PHILADELPHIA ELECTRIC COMPANY

Subject: Limerick Generating Station, Units 1 & 2
Information for Materials Engineering Branch (MTEB)
Regarding SER Confirmatory Issue #12 - Preservice
Inspection (PSI) Program

As discussed in the reference 1) telecon, attachment 4) provides additional information applicable to Relief Request No. 17. Attachments 1) through 3) and 5) through 7) result from the Owner and ANII reviews of the preservice inspection data.

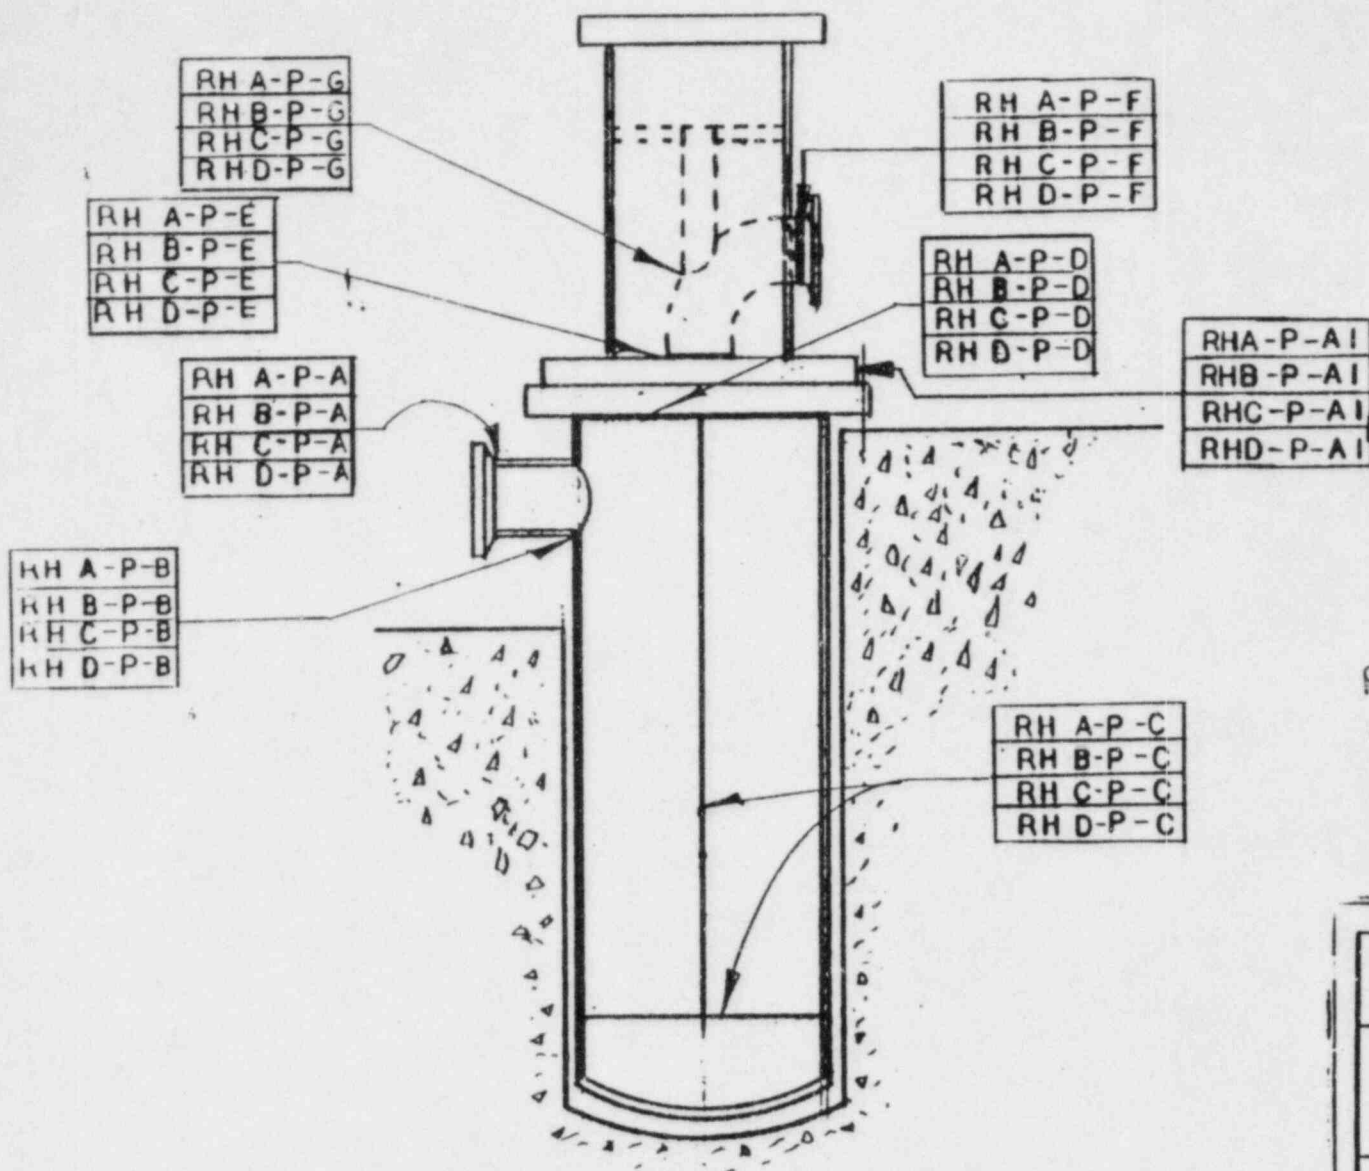
16. Class 2 Support Members for Piping
Code Item No. C2.5, Category C-E-1

Those pipe integrally-welded attachment welds included in Code Category C-E-1 of Table IWC-2520 shall be surface examined per Item No. C2.5 of Table IWC-2600. The examinations shall include 100% of the supports with attachment welds and shall be performed completely, once, as a preservice examination requirement. The examination surface shall include the attachment weld to the pressure retaining boundary plus the base metal beneath the weld and along the attachment for a distance of 2 support thicknesses.

Relief is requested from the area requirement of Table IWC-2520. For preservice inspection the examination surface shall include the attachment weld to the pressure retaining boundary plus the base metal beneath the weld and along the attachment for 1/2 inch on all sides. There are 141 supports included in this relief request.

Interpretation of the 1974 Edition of ASME Section XI, as modified by the Addenda through the Summer 1975, category C-E-1 requirements, leads to an examination area that includes large sections of pipe. In light of the provided interpretation, later editions of Section XI were considered to clarify the intent of category C-E-1 requirements. Therefore, the integral attachment welds included in category C-E-1 have been magnetic particle tested utilizing the coverage specified in the 1980 Edition of Section XI as modified by the Addenda through the Winter 1981, Figure IWC-2500-5.

nes NUCLEAR ENERGY SERVICES	
SYSTEM NO. 10	TITLE PHR PUMP BODY WELDS AND SUPPORT
REV: 2	FIG. NO. C1-27
BY: RP	DATE: 8-12-81
APP: CJZ	DATE: 11-4-81
PROJECT: 5551 LIMERICK UNIT 1	
NOT TO SCALE

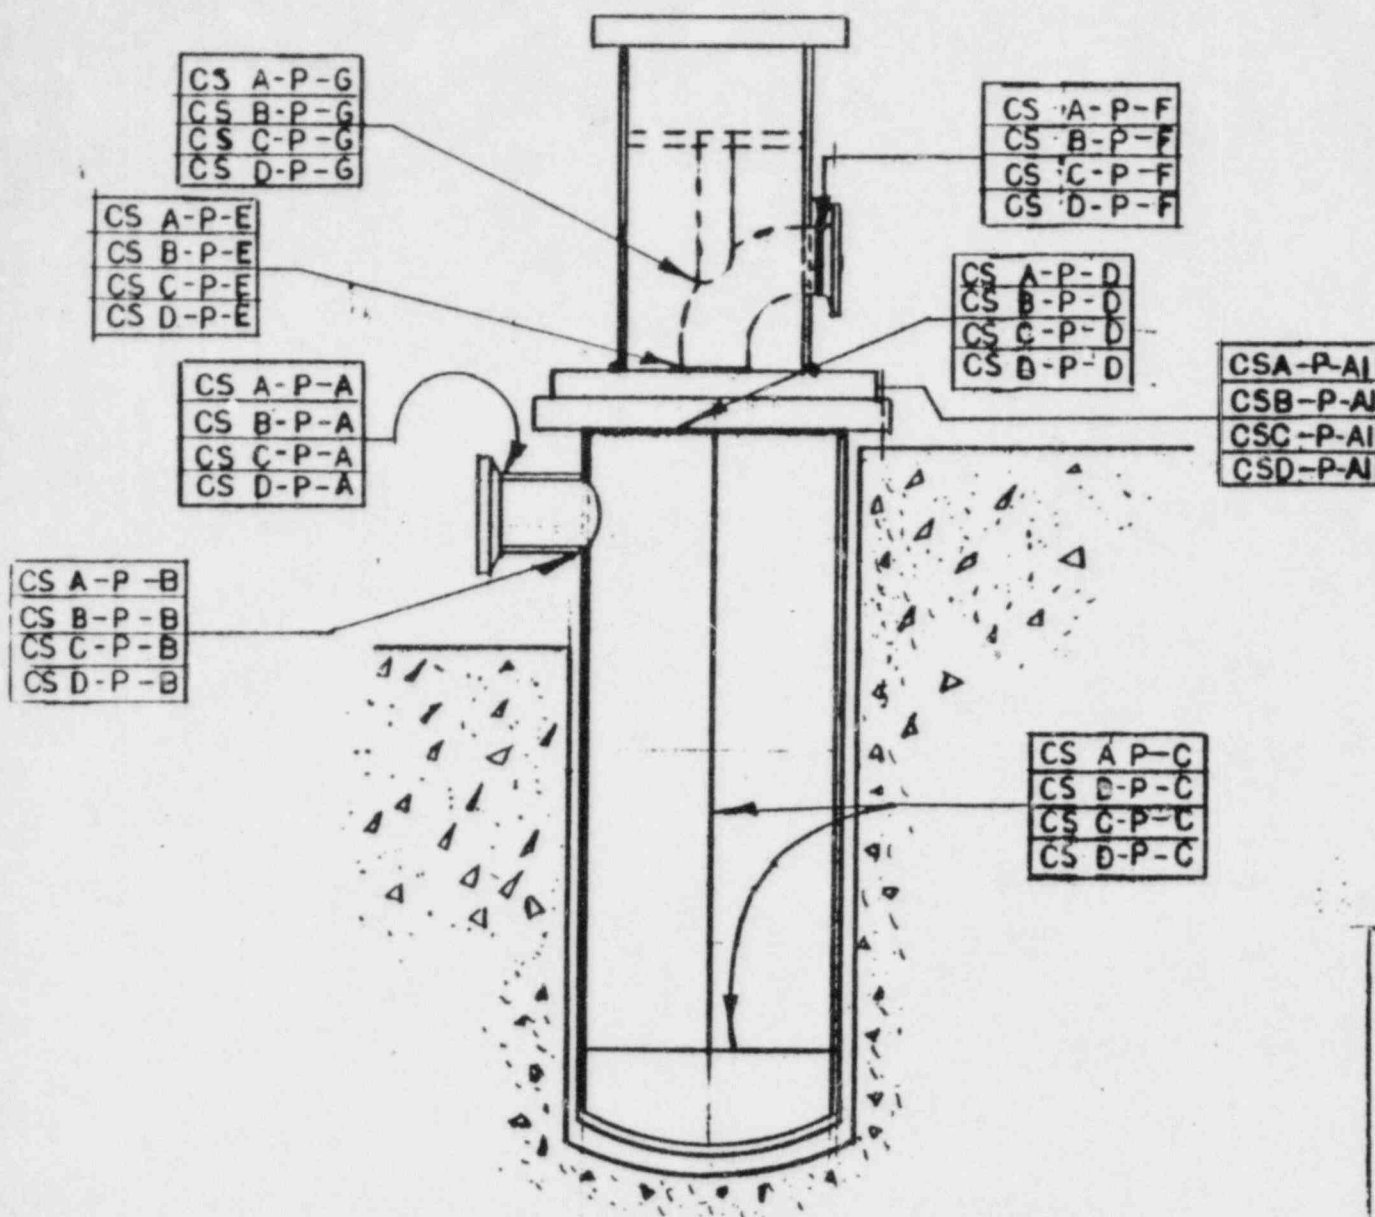
17. Class 2 Pressure Retaining Welds in Pumps
Code Item No. C3-1, Category C-F

Additional Information:

Included as additional information are the following:

1. Weld identification figures from the Preservice Program Plan, 801558 for both the RHR and Core Spray pumps.
2. Excerpts from the Core Spray pump Owners Manual (including General Arrangement Diagram) which provide general design notes for the pump foundations. These notes are typical of both RHR and Core Spray Pumps.
3. Photographs (3) showing the pump foundation arrangement at the inlet nozzles for both the RHR and Core Spray pumps.

Inservice inspection of those pump shell welds that are encased in cement must be deferred until such time that the pump is removed for maintenance. Either visual, surface or volumetric examinations may be performed depending on ALARA considerations and equipment availability. Visual examinations from the exterior will be performed during system pressure tests. Shell leakage can be detected at the foundation construction joints.
